To:	Jemma Foster	From:	Rahul Dixit
------------	--------------	--------------	-------------

Planning App Ref:	PL/2026/01506
Service Ref:	Drainage
Date:	17/04/2026

Full planning application for demolition of redundant stone barns; erection of children's nursery with new access, car parking, secure garden and associated landscape and drainage works (Class E); installation of new vehicular access and parking area to retained Southview Farmhouse, erection of replacement rear conservatory, erection of car park, associated erection of boundary treatment, and associated drainage and landscaping.

Southview Farm, Drynham Road, Trowbridge, BA14 0PJ

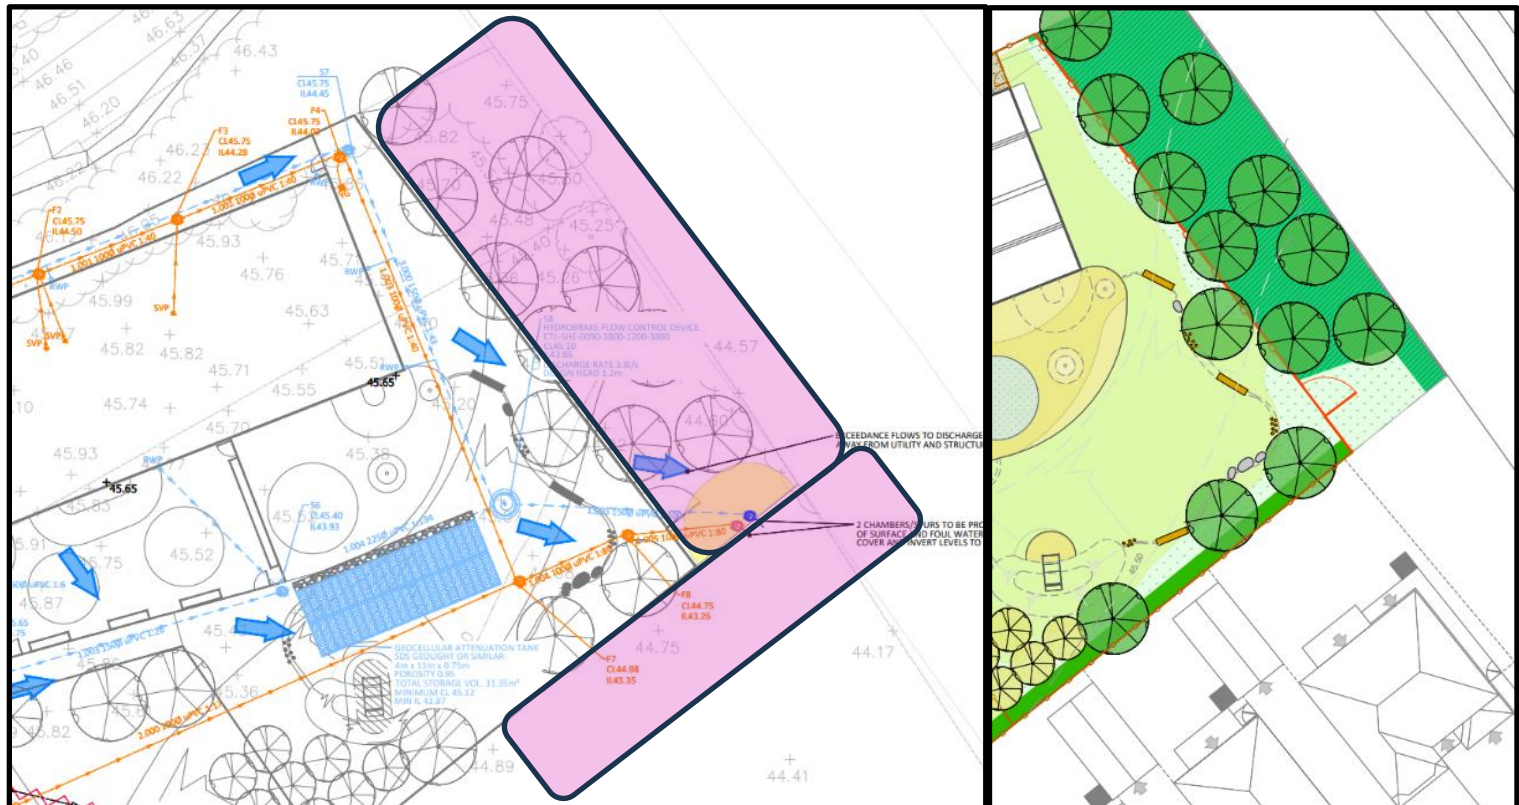
1. We note the applicant has stated in section 3.1 of the Drainage Strategy Statement that Redrow Housing have agreed to accept flows discharged at 3.8l/s. The applicant must provide a statement that demonstrates this agreement with Redrow Housing and acknowledges that any future drainage design and planning application on the Redrow Houses site will include a 3.8l/s discharge.
2. Post-development exceedance routing plans indicate that surface water exceedance flows are directed towards the future proposed development by Redrow Housing and the existing railway corridor.

The applicant is required to submit further details demonstrating how exceedance flows will be safely managed in the pink areas, demonstrating how exceedance will not increase flood risk to the future Redrow Housing development and the existing railway infrastructure. The LLFA would expect the applicant to manage flows onsite, without directing flows towards existing or proposed development.
